**MACQUARIE**  
University

15<sup>th</sup> April 2016

## **BACKGROUND AND KEY CONDITIONS**

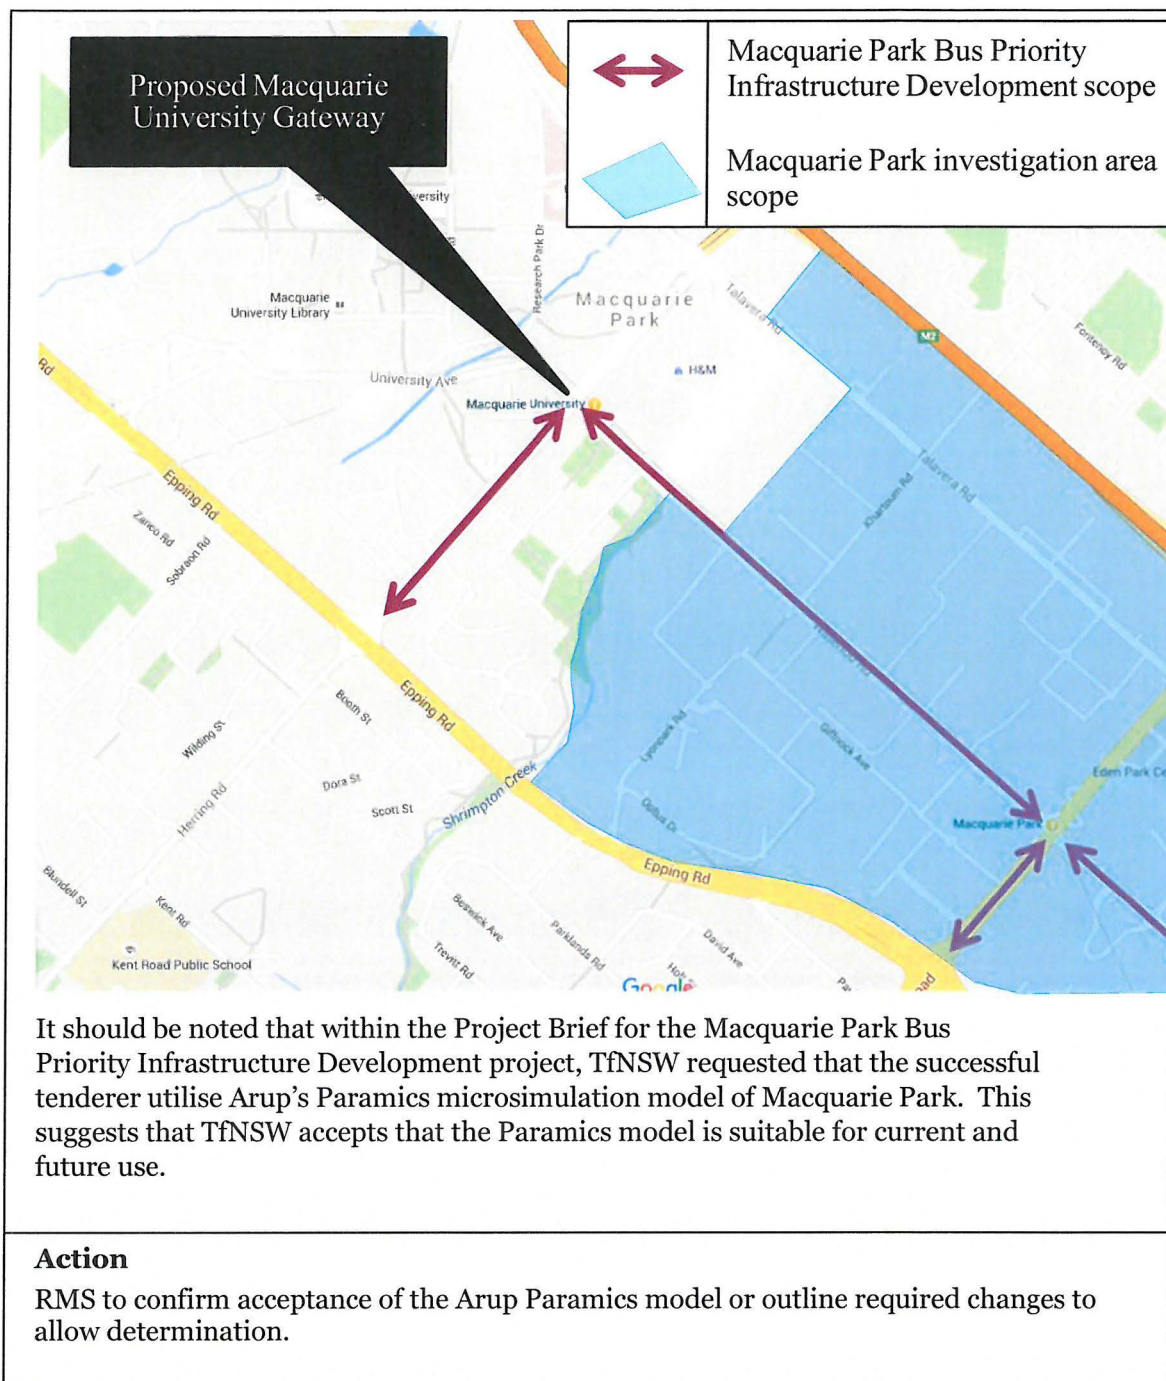
The RMS letter refers to two ongoing projects currently being undertaken by the NSW Government (see plan below). The projects and likely impacts on Macquarie University are:

- Macquarie Park - Bus Priority Infrastructure Development (currently being undertaken by Arup) – located on Herring, Land Cove and Waterloo Roads. No impact on Macquarie University modelling; and
- Macquarie Park Strategic Investigation (currently under assessment by the Department) – located east of the Macquarie Centre. No impact on Macquarie University modelling.

As illustrated in the figure below, these two projects lie outside the Macquarie University precinct and would not impact the operation of internal roads within the campus.
